North Park Isles - Peer Review

For the City of Plant City

November 10 2017

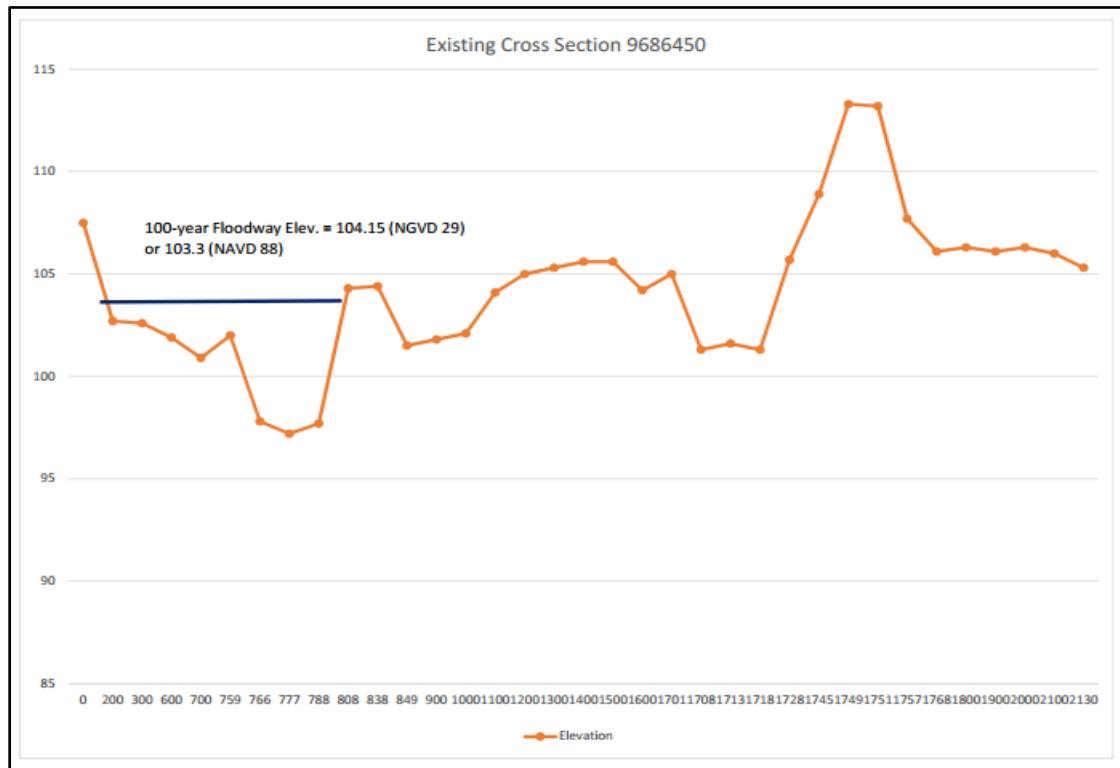
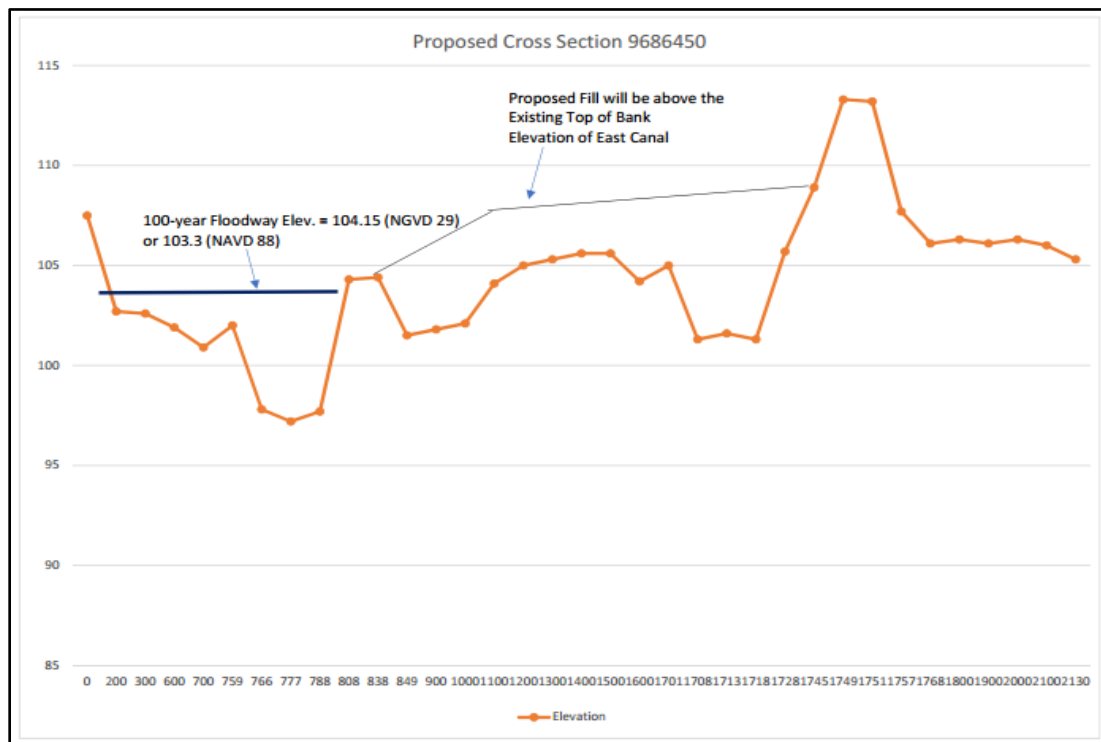
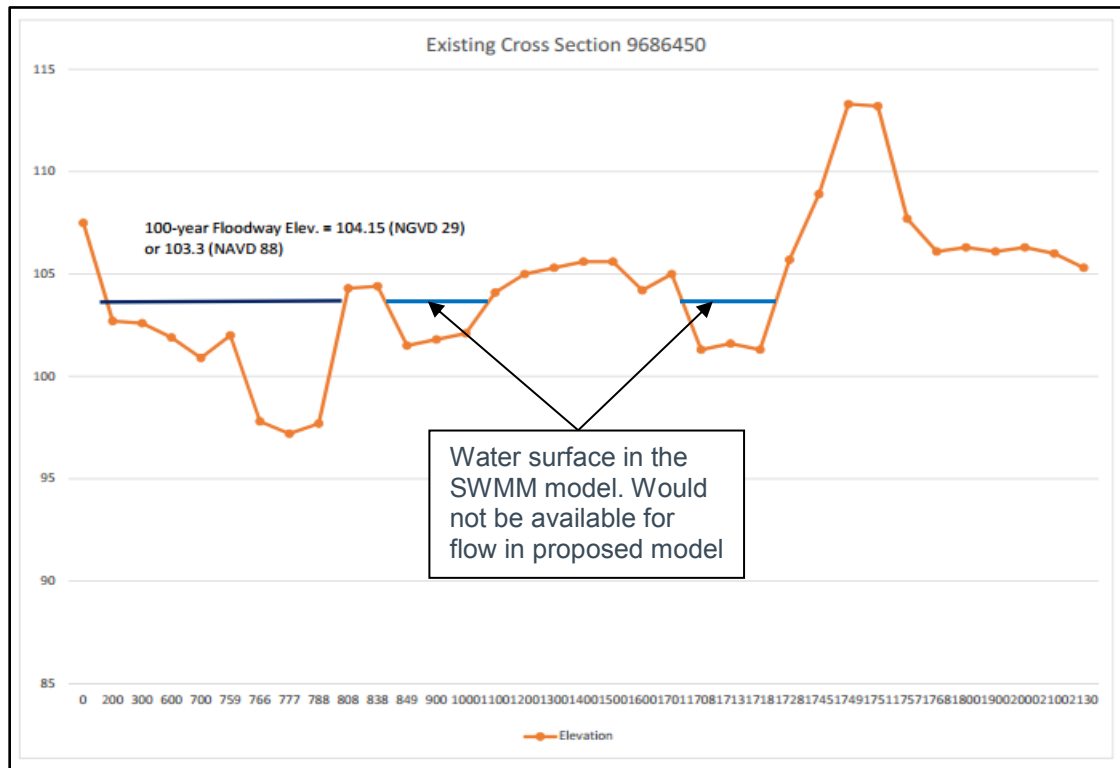
According to the AEI report, only steps 1 and 2 were completed. The no-rise certification analysis is based on the assumption that flow is contained within the primary or main channel of the effective model cross section. **Figures 2-1 and 2-2** below show the cross section in question and there are graphs in Appendix C from the AEI report. The flaw in this justification is that, in SWMM, flow is conveyed anywhere in the cross section below elevation 103.3 NAVD88 (104.15 NGVD29), which includes stations 849 – 1000 and stations 1708 – 1718 within the cross section. **Figure 2-3** presents this in a graphical format. This was tested by Atkins staff by eliminating the portion of the cross section beyond station 808 (which is the portion in which the development is encroaching in on the cross section). The results of this modeling analysis are presented in **Table 2-1**. As can be seen in the table, there are rises in peak stages for over fifteen (15) nodes along the floodway, for which no rise is allowed (meaning 0.00 feet of rise).

Floodway Comment 1 – Conduct floodway analysis that shows no rise in peak stage in the floodway (0.01 foot is considered a rise).²

Figure 3-1 Area of Impacted Floodplain on Adjacent Properties

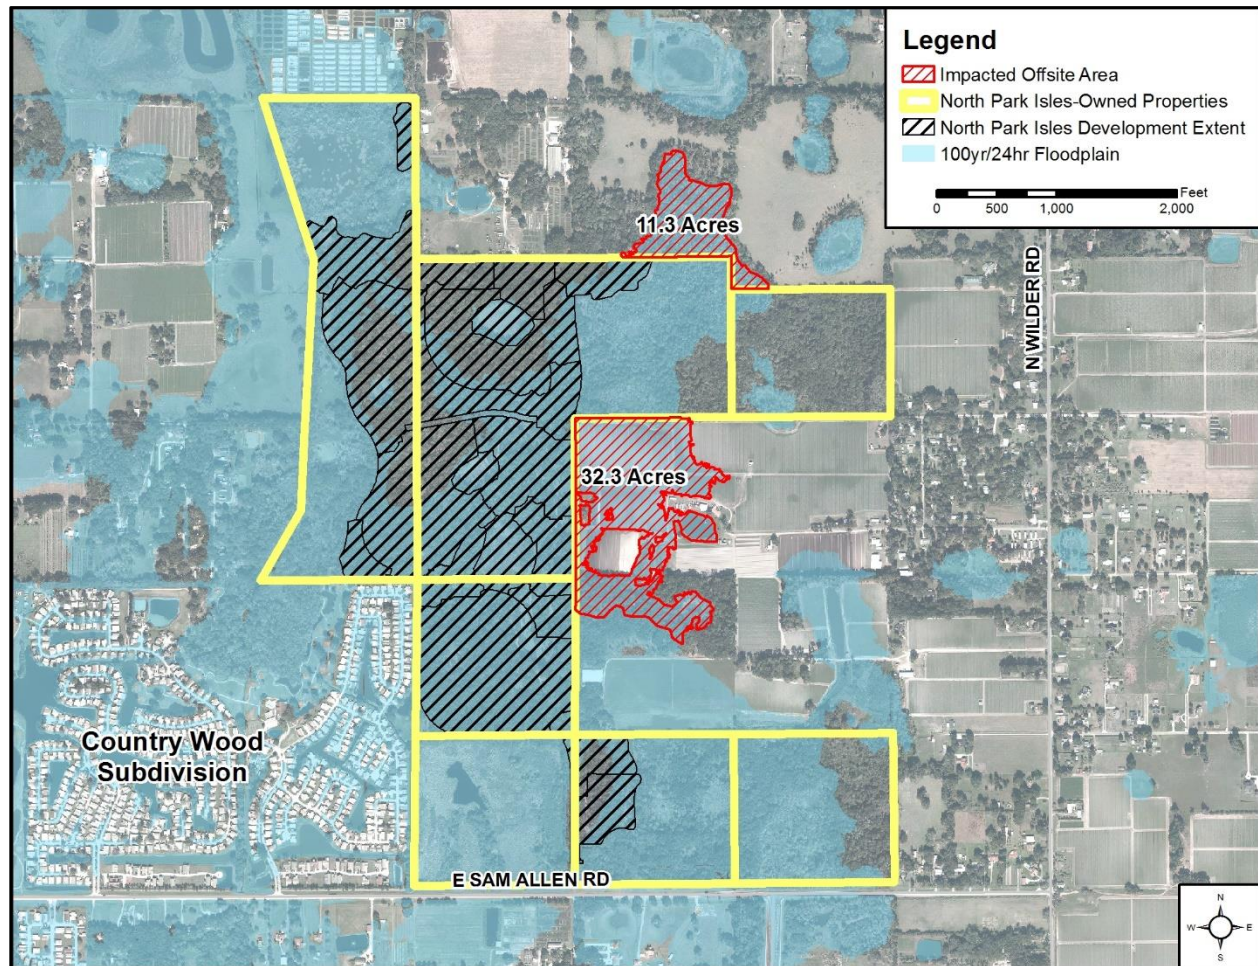
Tables 4-1 – 4-4 of the AEI report present the peak stage and peak flow model results from the from the “sub-model” revised existing conditions, “sub-model” proposed conditions and the peak stage/flow differences for the 2.33-yr/, 10-yr/, 25-yr/ and 100-yr/24-hr storm events. The one junction that stands out in each table is node 686442. This node shows a substantial increase for each storm event. The report indicates that the increases are “on-site”. But according to the property appraiser, the property is not currently owned by the North Park Isles, LLC. **Figure 3-1** shows the areas of floodplain impacts on adjacent properties.

Report Comment 1 - Please verify/show property ownership or reduce flood stage to existing conditions on adjacent property.

Figure 3-2 Weir overflow 6686442 model input versus survey data

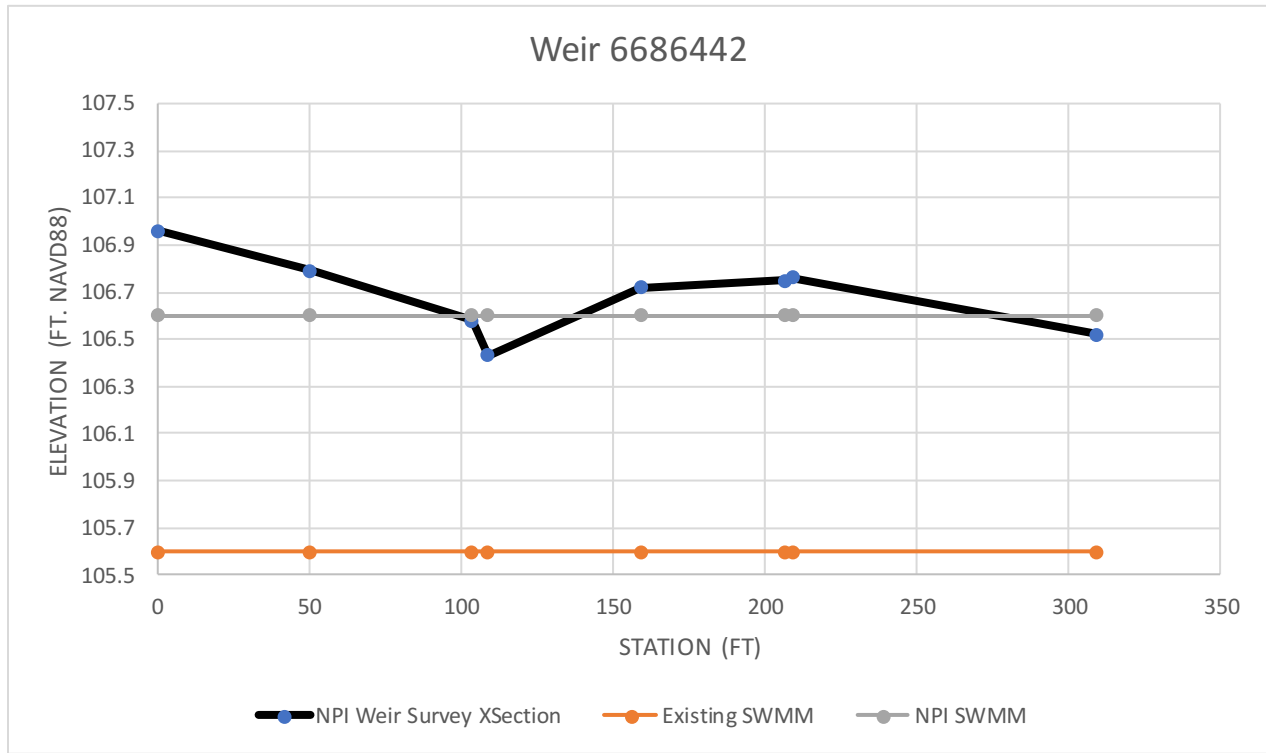
Based on the comparisons, the modification to weir 6686442 appears to represent actual conditions well, based on the project survey data (grey line versus thick black line in **Figure 3-2**). However, weir 6686825 does not. When examining the survey data grade line (black line in **Figure 3-3**), it can be seen that the model overflow elevation (grey line in **Figure 3-3**) is well above the survey data.

Figure 3-3 Weir overflow 6686825 model input versus survey data

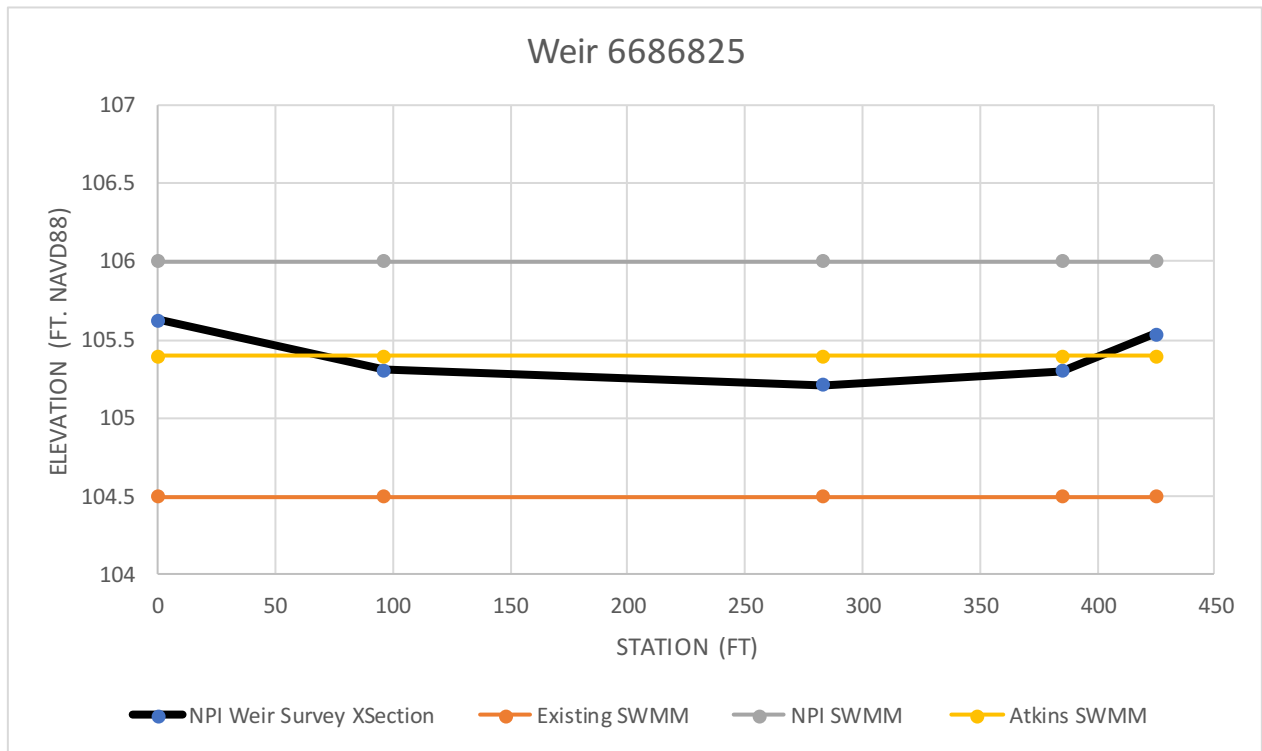
Report Comment 2 – Modify weir invert elevation to 105.4 ft. NAVD88 to more accurately represent ground existing ground conditions (yellow line in **Figure 3-3**)

Figure 3-4 Current Extent and Recommended Extent of Sub-model

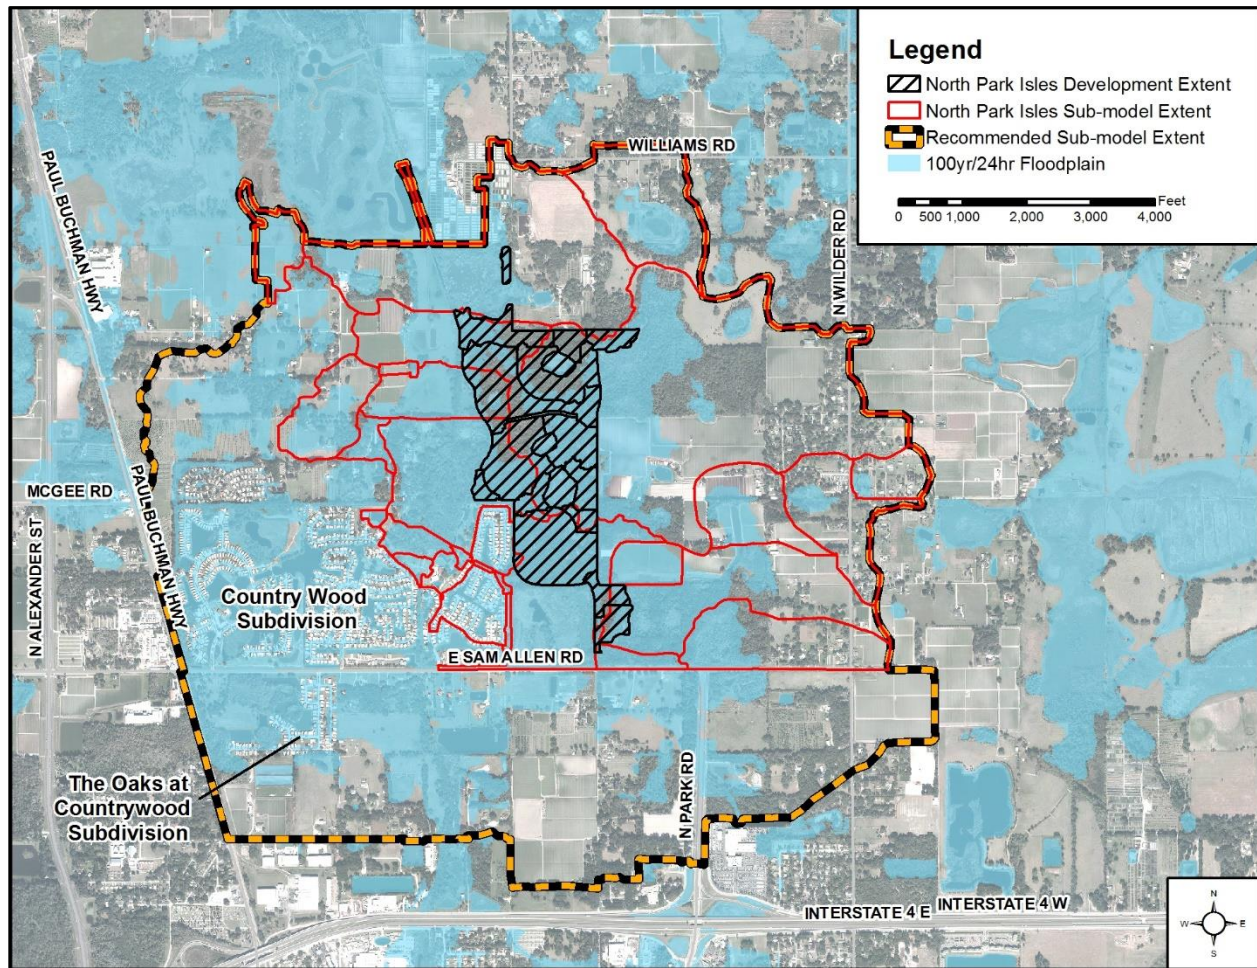
Existing ICPR Comment 1 – Based on the discussion above, Atkins would recommend extending the sub-model further south and to the west. **Figure 3-4** shows the recommended extent of the sub-model versus the existing extent of the sub-model. This would provide a means of assuring that no adverse impacts are caused by the proposed development for the, already flooding sensitive, communities of Country Wood Mobile Home Park and The Oaks at Country Wood.

Figure 3-5 Areas of Duplicated Storage within the Model

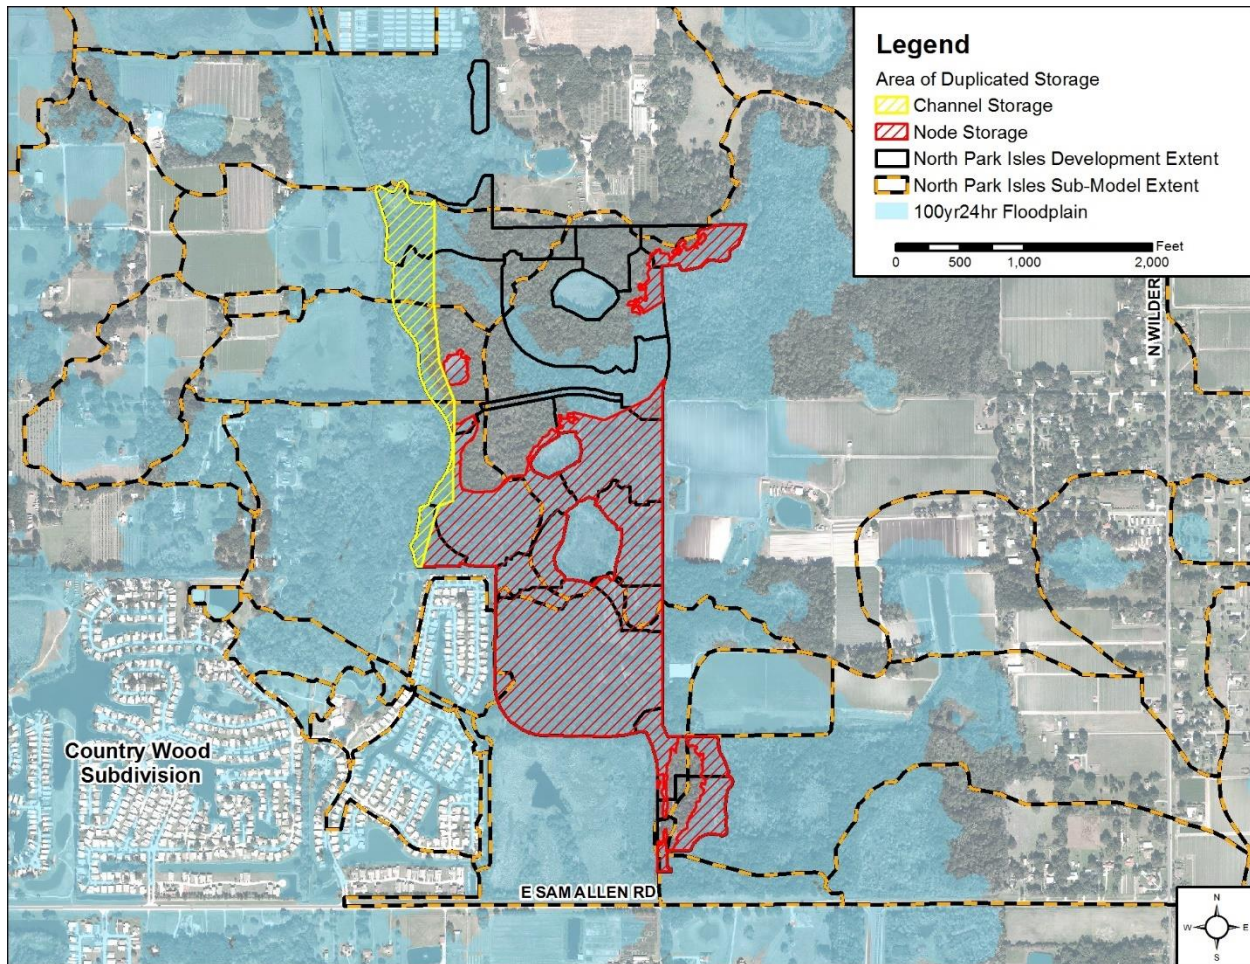
- Nodes/Channels
 - Storage
 - Stage area relationship within proposed North Park Isles Development
 - Appears reasonable – **No Comments**
 - Surrounding existing offsite subbasins
 - Subbasins that do not overlap North Park Isles development
 - Appear reasonable – **No Comments**
 - Subbasins that overlap North Park Isles development (Shown in **Figure 3-5**)
 - Storage volumes were not reduced to reflect the proposed fill from future development, storage has been duplicated in nodes 686440, 686450, 686455, 686442, 686825, 686830, 686475 and 686840.
 - Channel cross sections along East Canal were not modified to reflect development encroachment into channel cross section bank areas (channel cross sections 9686470, 9686455 and 9686450)
